SALES BULLETIN

## Design Change Notification: Electrak® Pro Linear Actuators

**Date:** July 23, 2018

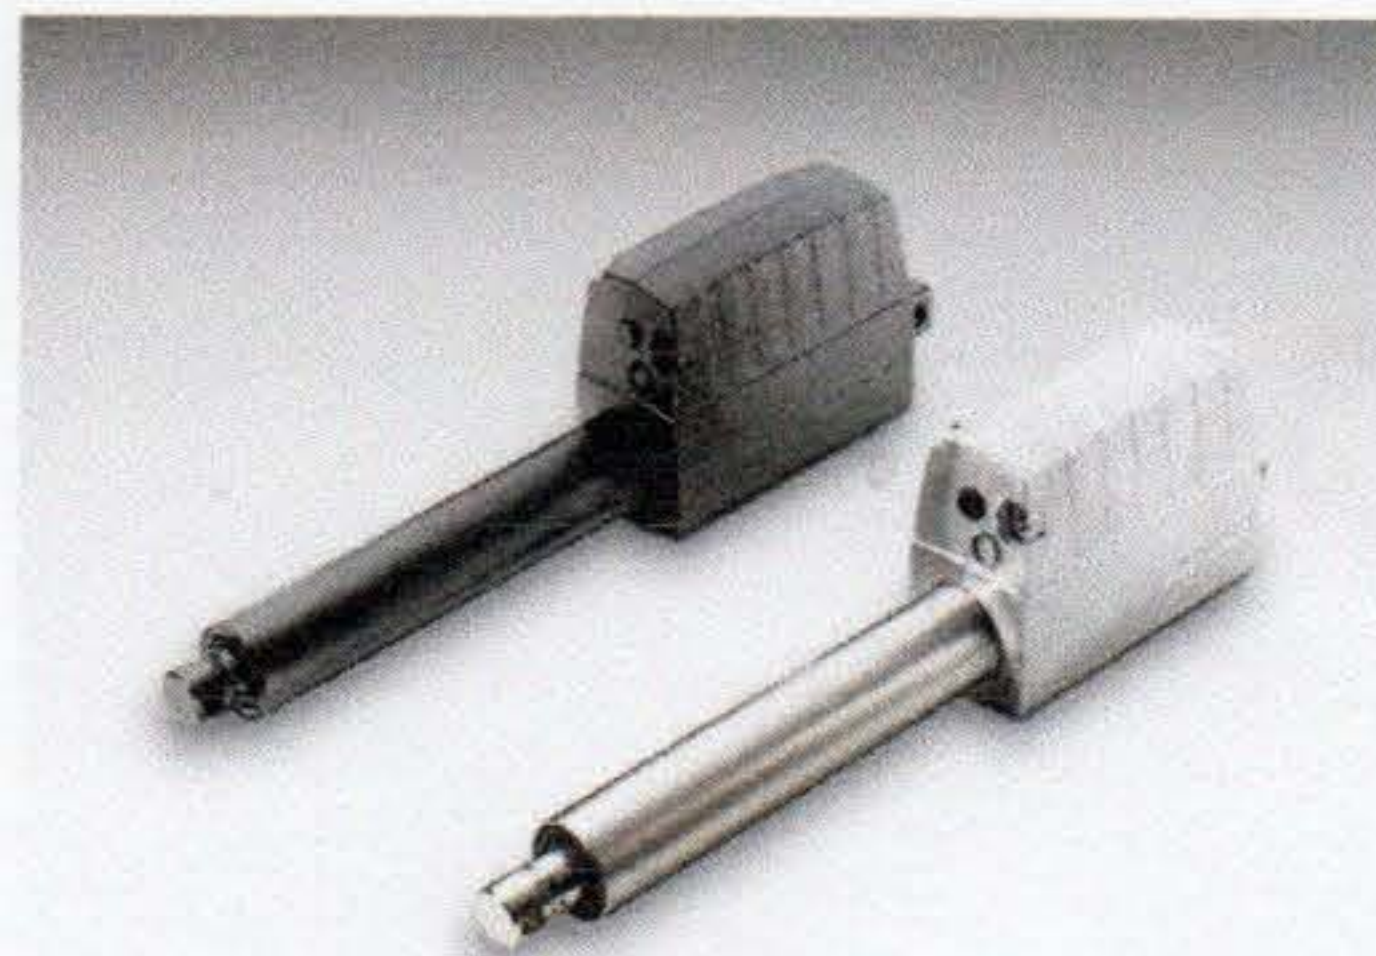
We are writing to announce that the Thomson engineering team has successfully implemented new design changes that will impact all current Electrak Pro linear actuator part numbers effective September 4, 2018. As part of our commitment to continuous improvement, the team completed this product enhancement project, which focuses on the actuators' robustness and sealing without altering its functionality. Enhancements include:

- The actuator housing has been expanded 1.2 mm in every direction, while the retracted length dimension remains the same.
- The bi-directional rear clevis has been replaced by a uni-directional rear clevis.
- The Electrak Pro design is now rated for IP66, IP67 and IP69K.

New part numbers for these models also will be implemented on September 4. Electrak Pro actuators previously ordered with a part number starting with PR12 or PR24 will now be ordered with PN12 or PN24.
